511 Capitol Building Stabilization Project IOWA CITY, IOWA 10271-10004

ADDENDUM 02

December 2, 2025

This addendum forms a part of the Contract Documents and modifies the original bidding documents dated November 14, 2025, as noted below.

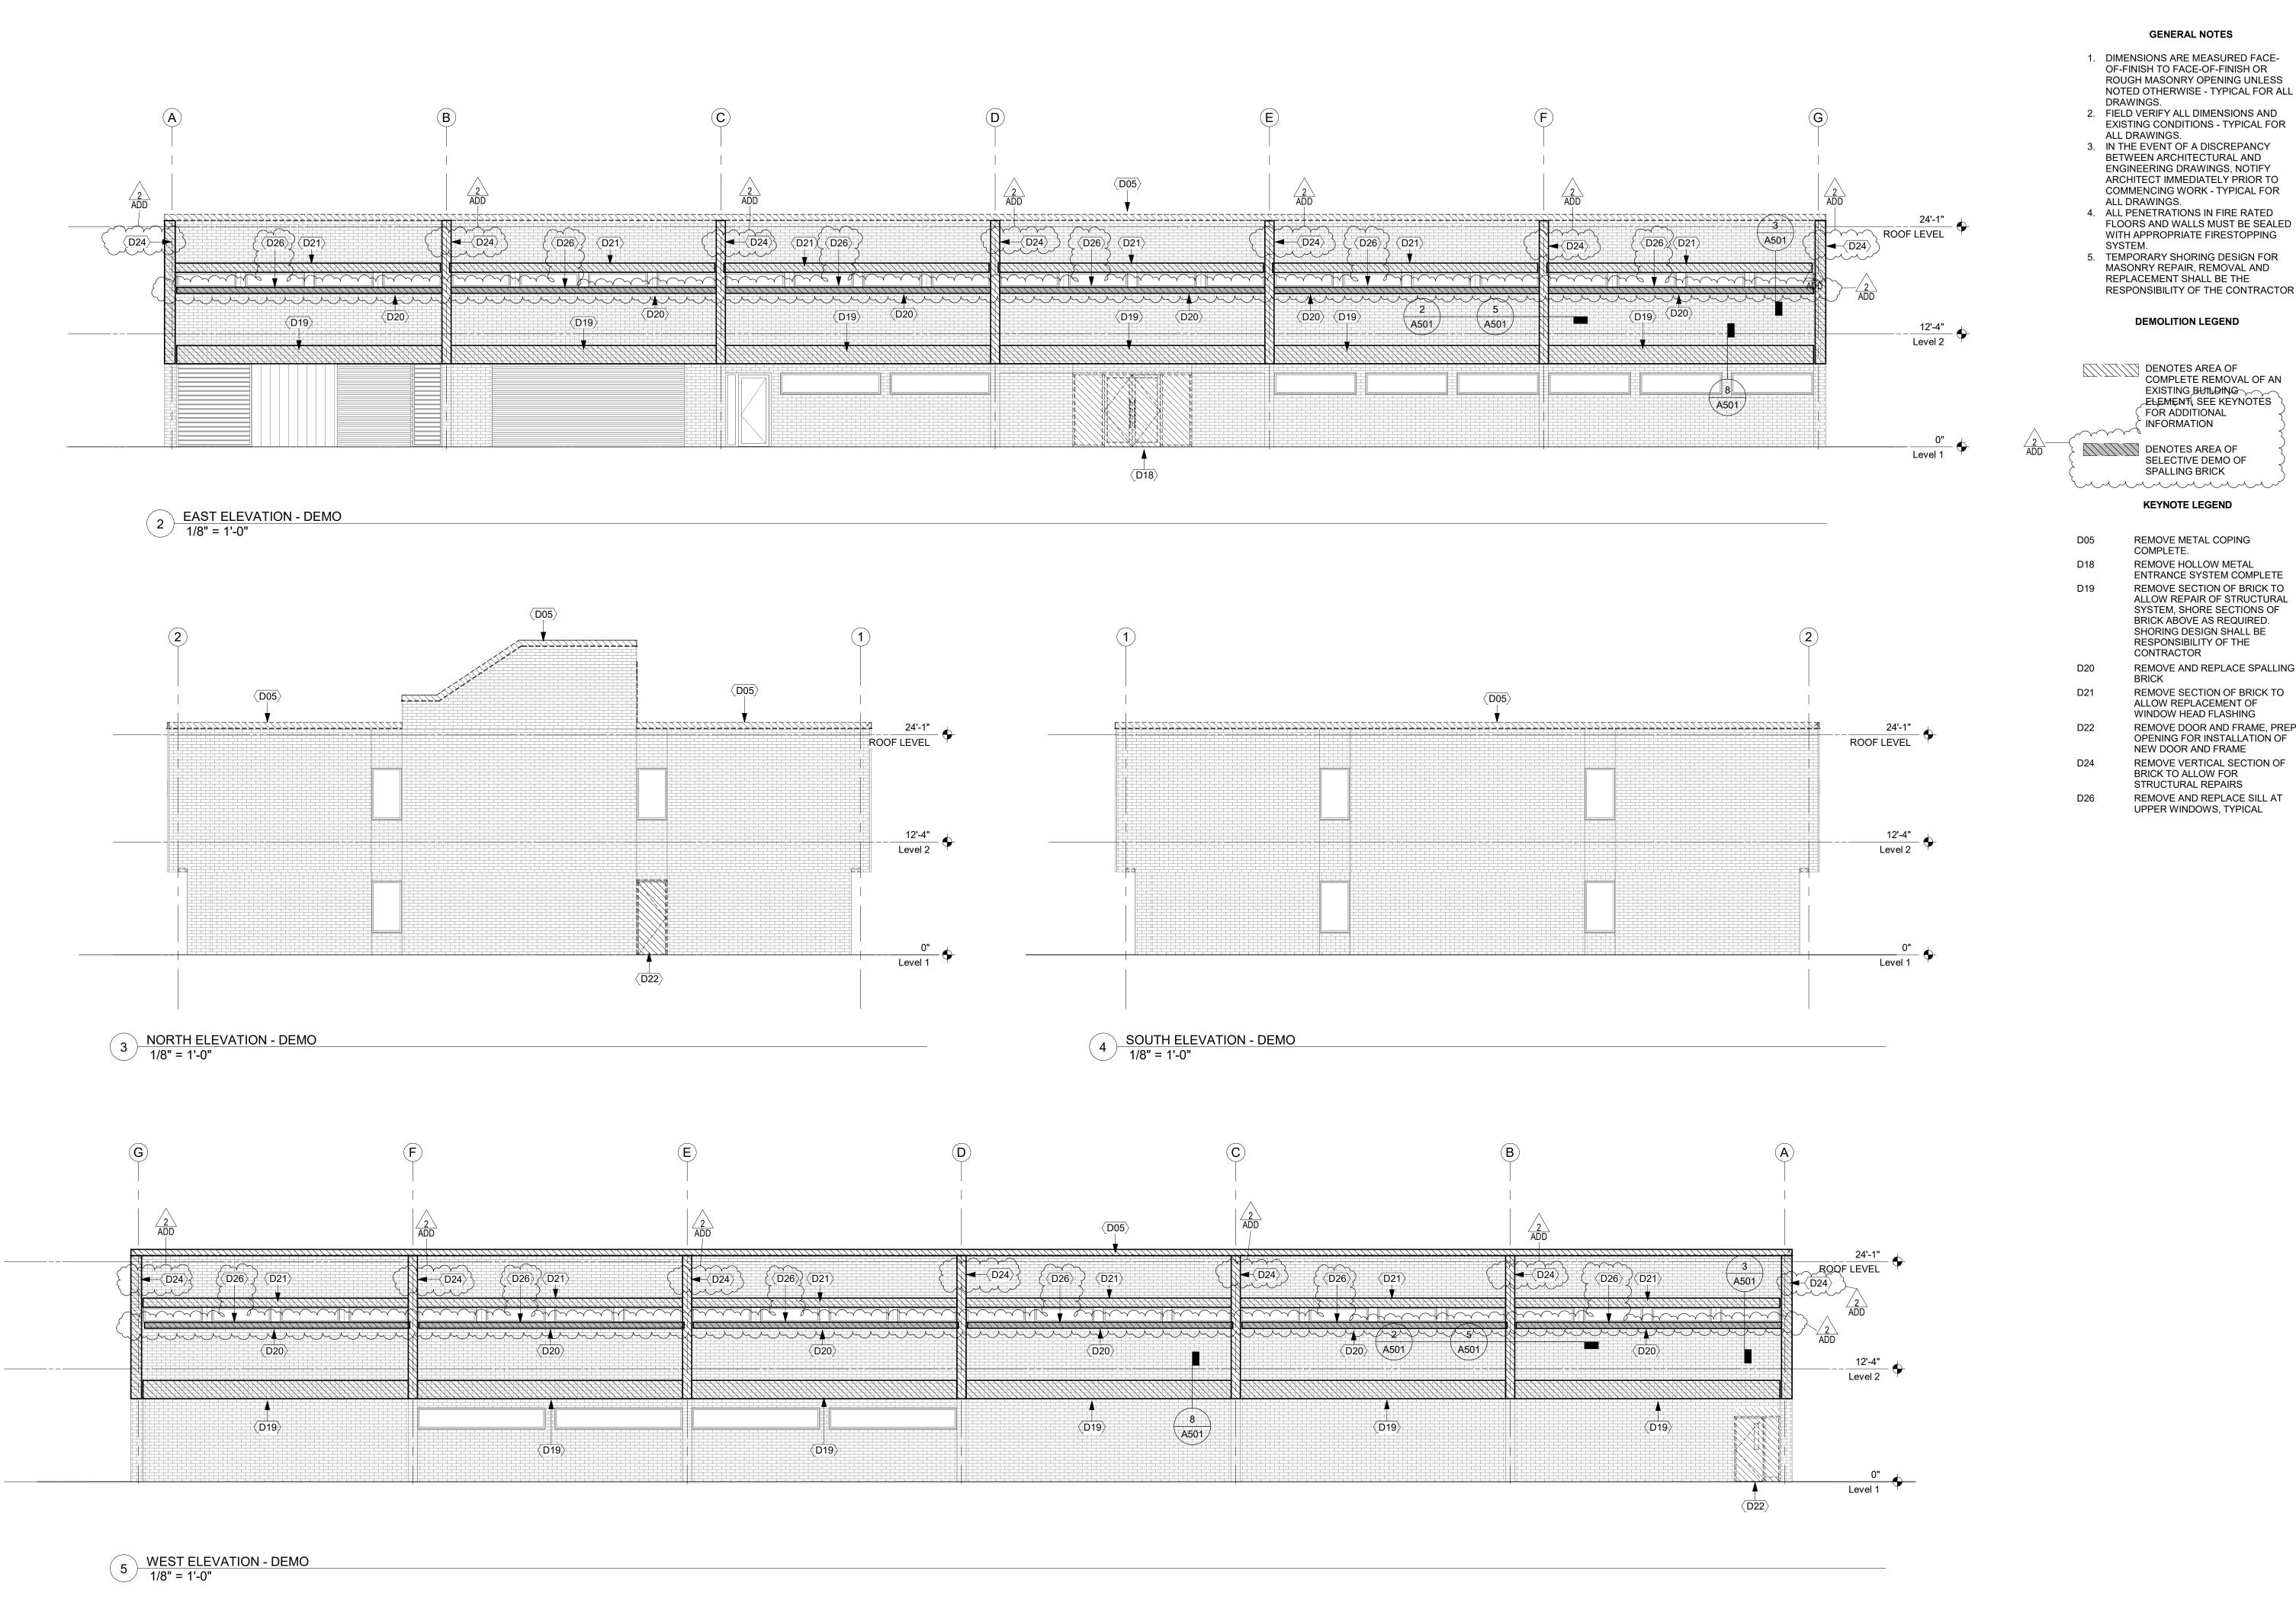
- 1. ADDED Refrigerant pipe dog house note for existing Daikin Mini-split system.
- 2. ADDED Refrigerant pipe dog house note for new mini-split system, <u>UV-1</u> and CU-1.
- 3. REVISED Cooling tower CT-1 note to include pipe connection size.

AD201

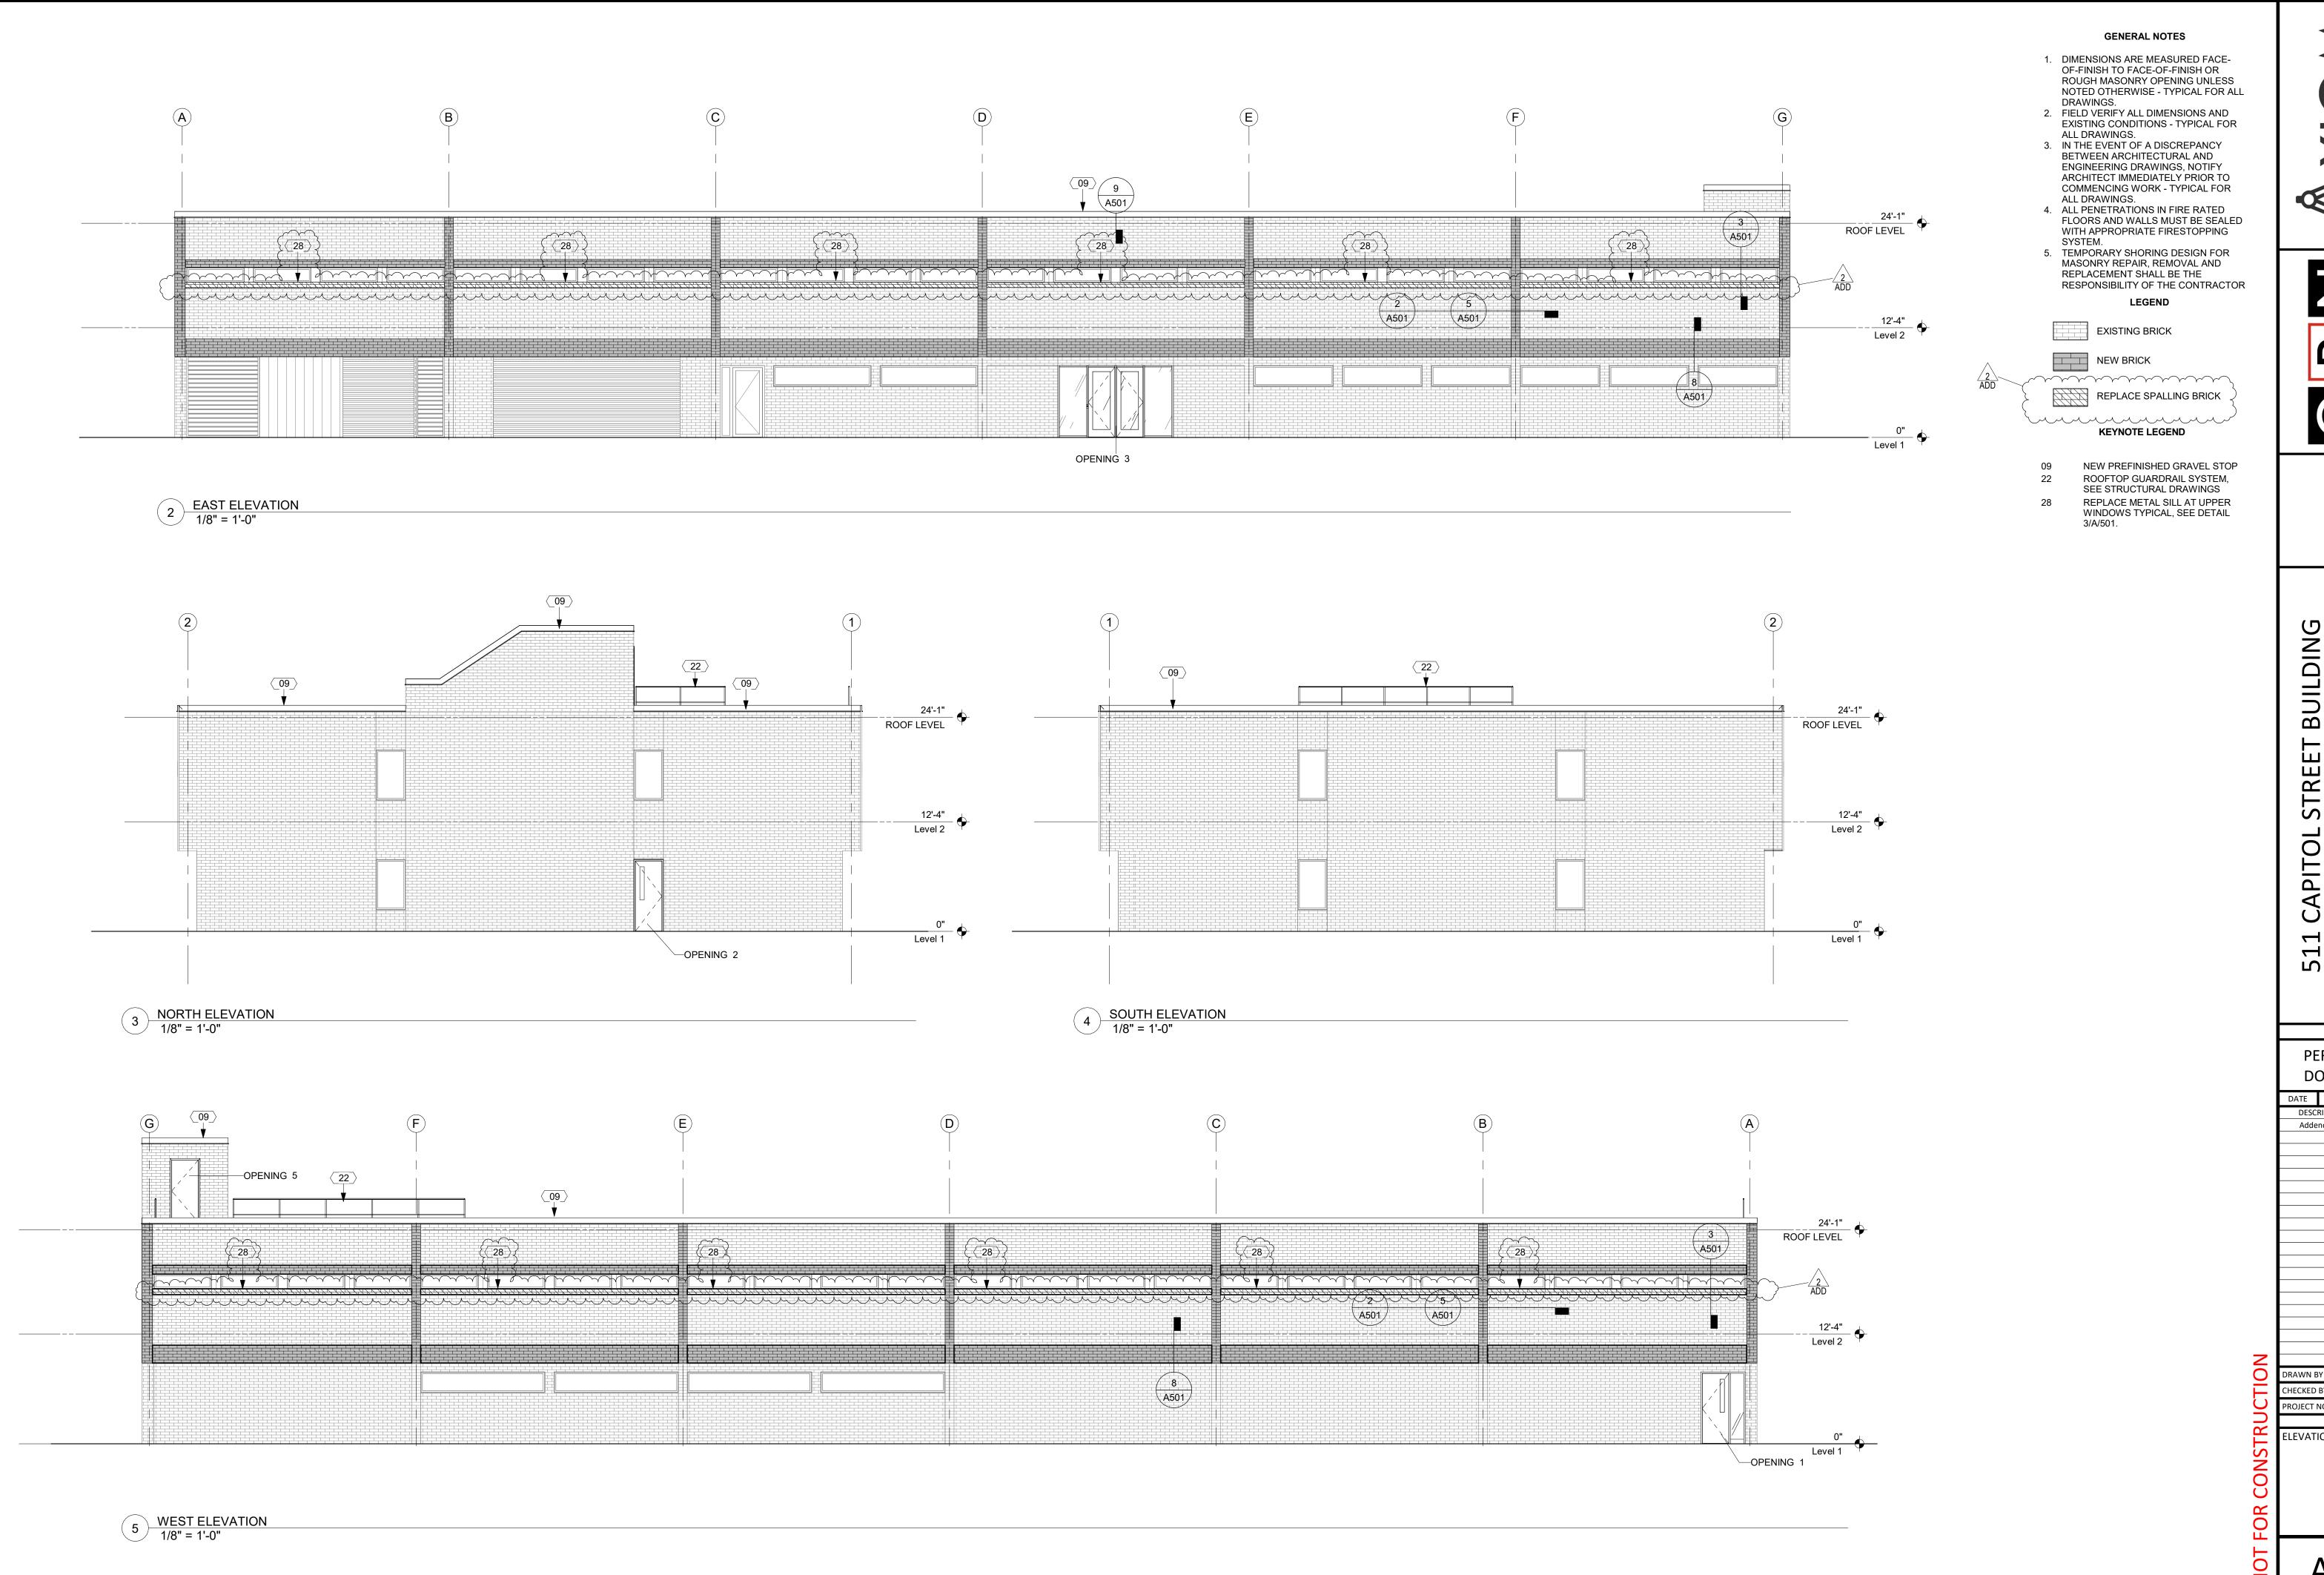
- 1. REVISED Keynotes and area hatching to clarify masonry demo scope
- 2. ADDED Keynotes for upper window sill replacement

A201

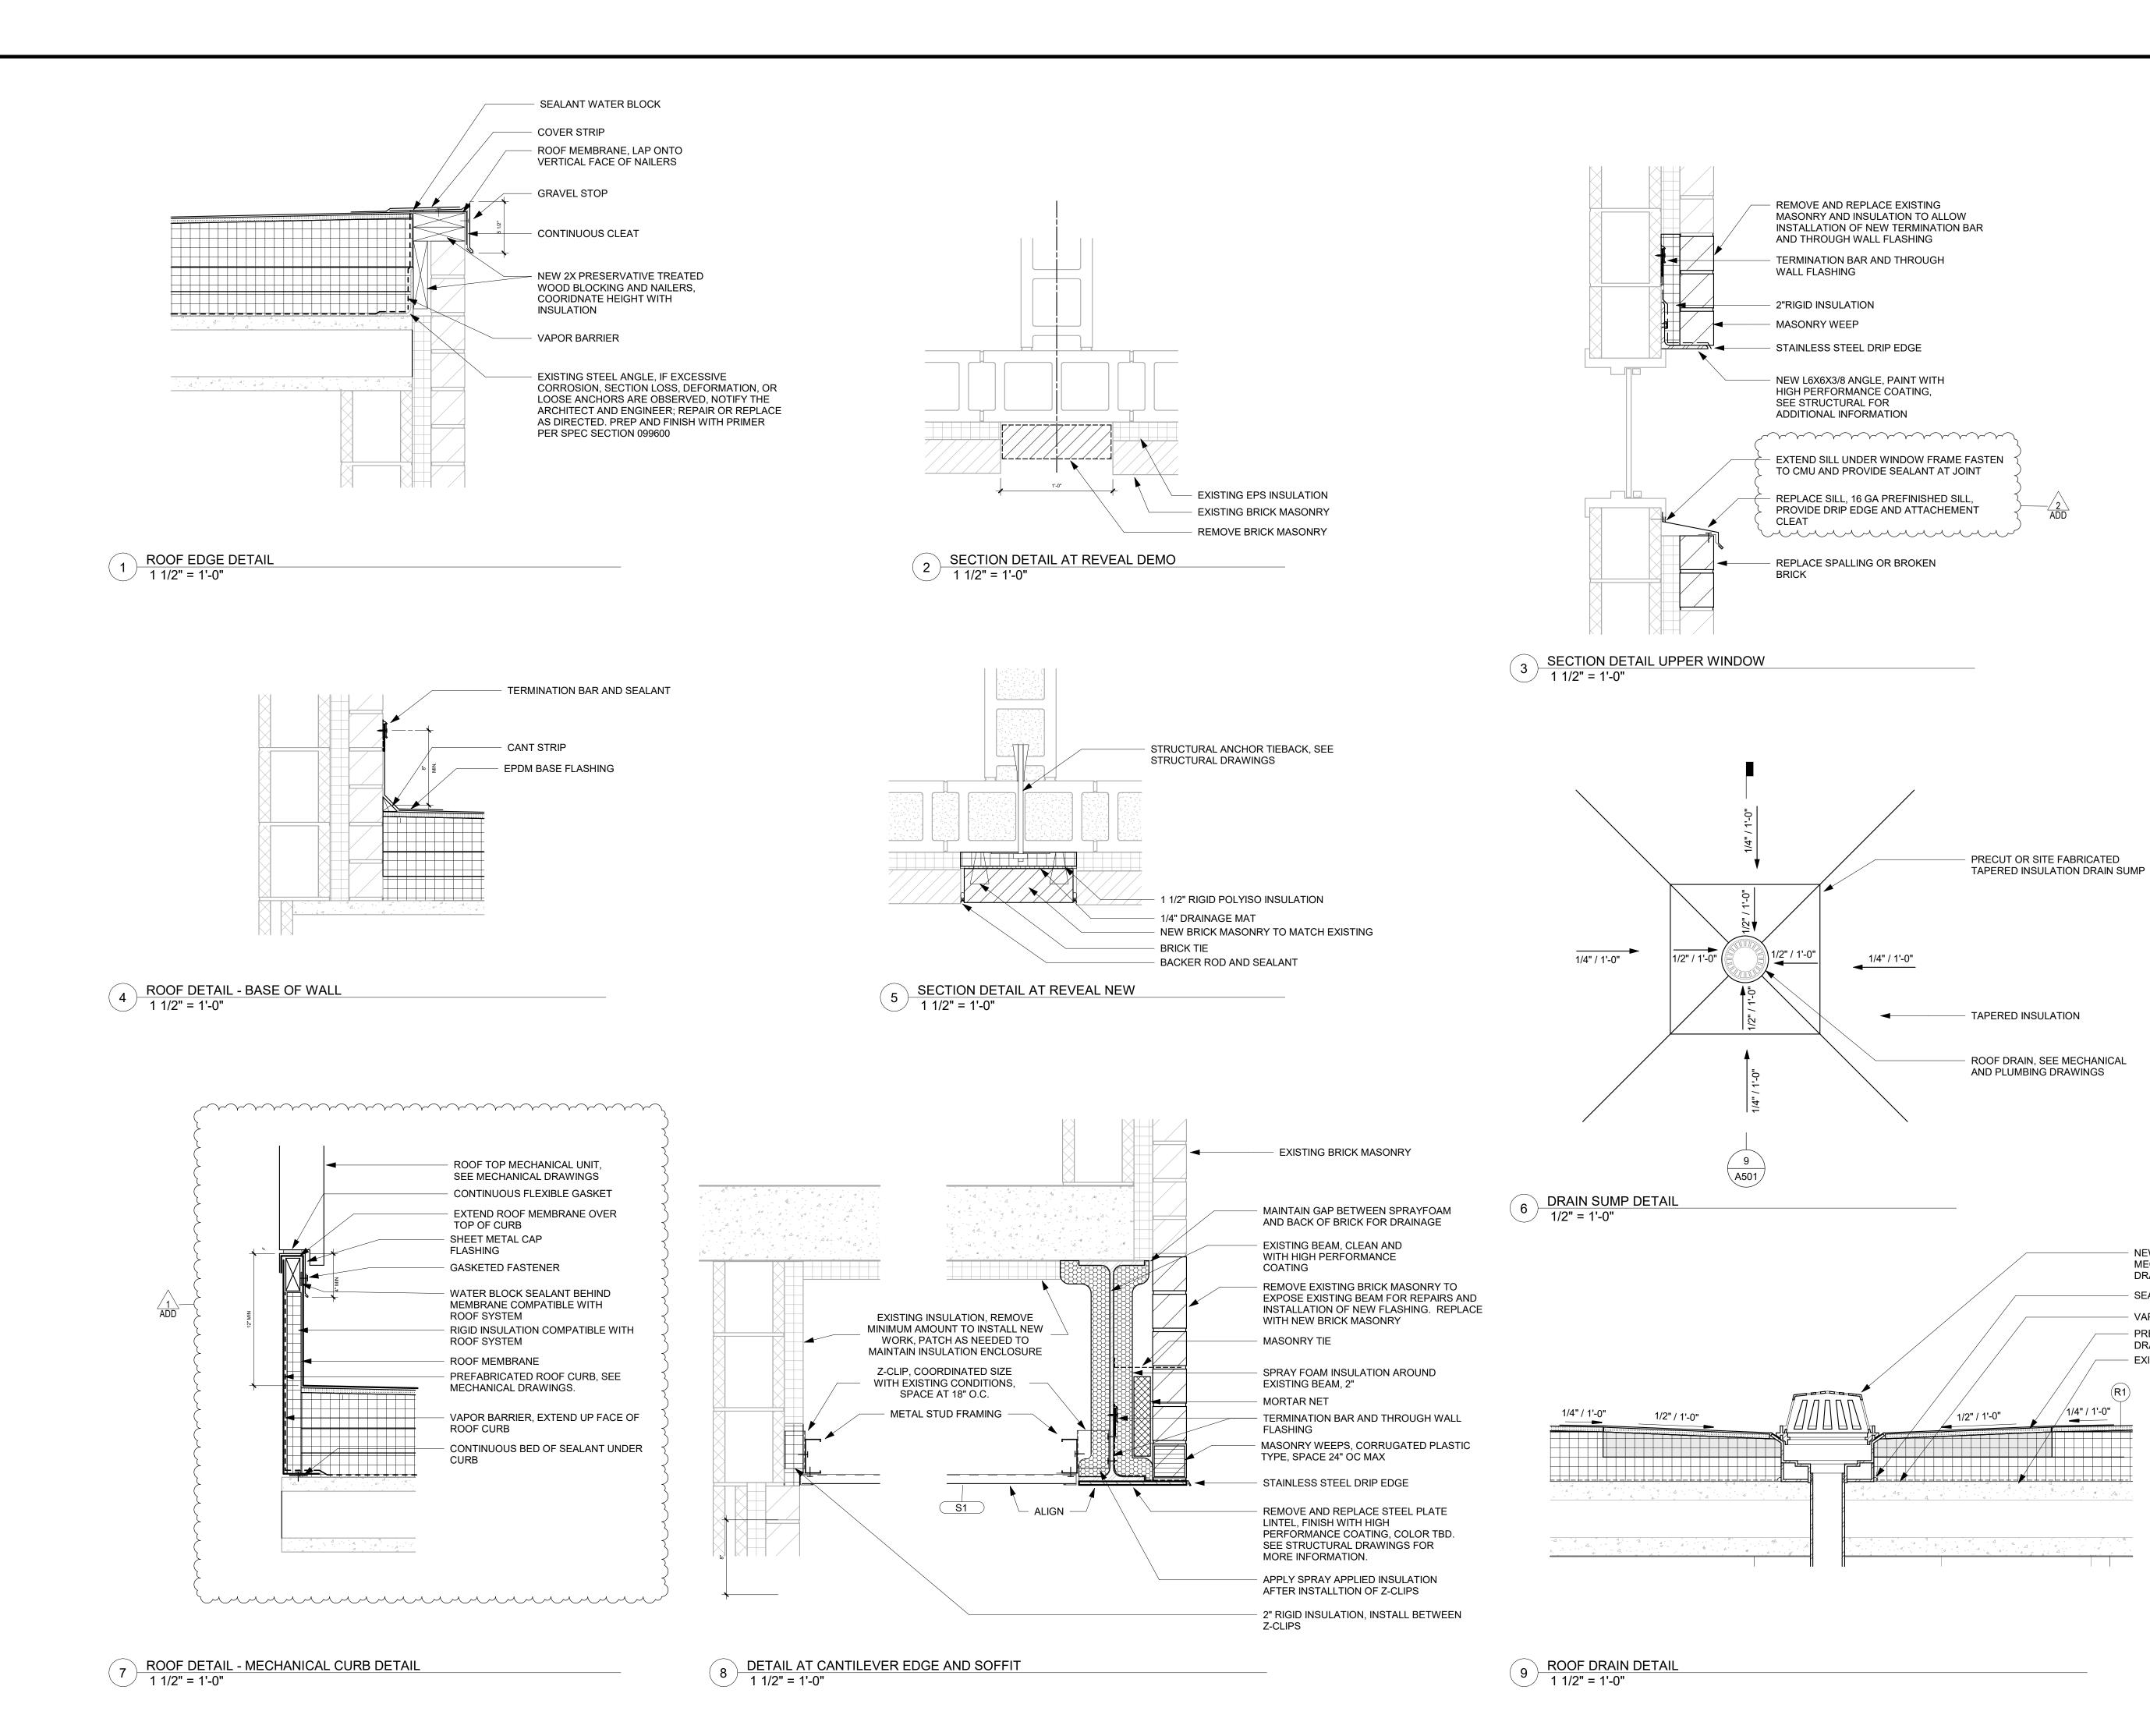
- 1. REVISED Area hatching to clarify masonry replacement scope
- 2. ADDED Keynotes for upper window sill replacement
